## Fuel Filter

### SB-ASTM-CTSW-04

## FLIGHT DESIGN USA SAFETY DIRECTIVE No.13

C9997813G

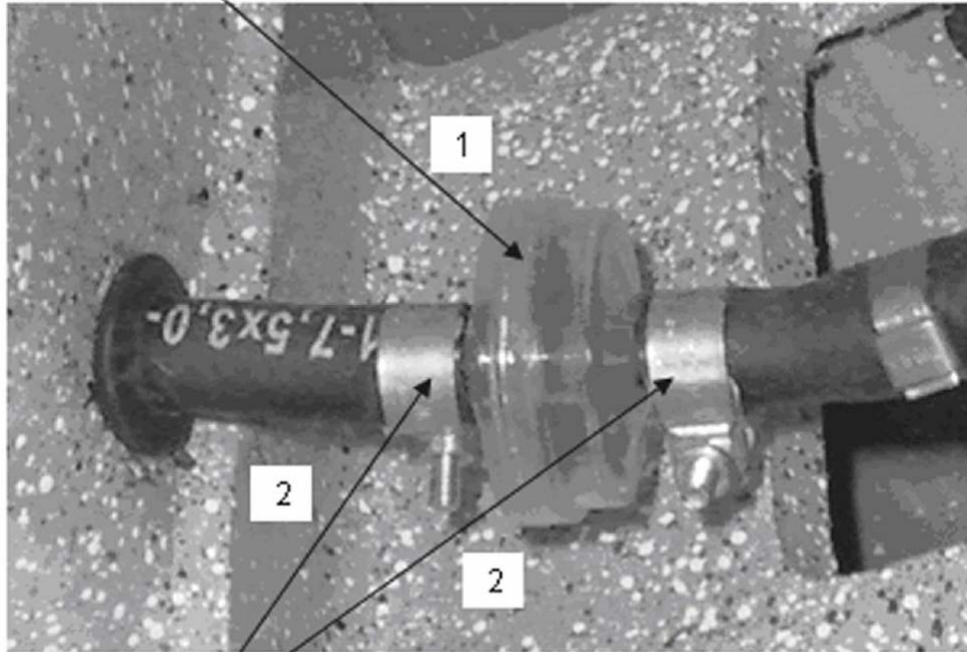
To streamline production, and to promote fleet uniformity, all CTSWs are now being delivered with a 400-micron fuel filter originally specified for Dynon equipped aircraft only. By extension, the factory has authorized a retrofit of all existing CTSWs and 2006 CTSWs from the original in-line filter to the new 400-micron filter. Flight Design USA believes the 400 micron filter to be superior for all applications and by such is mandating the replacement of the original filters (part No.C9997793) By the new style filter (part No.C9997813G).

At the next periodic inspection interval or the next annual inspection whichever comes sooner, any aircraft equipped with the original filter will be retrofitted with the new 400 micron filter.
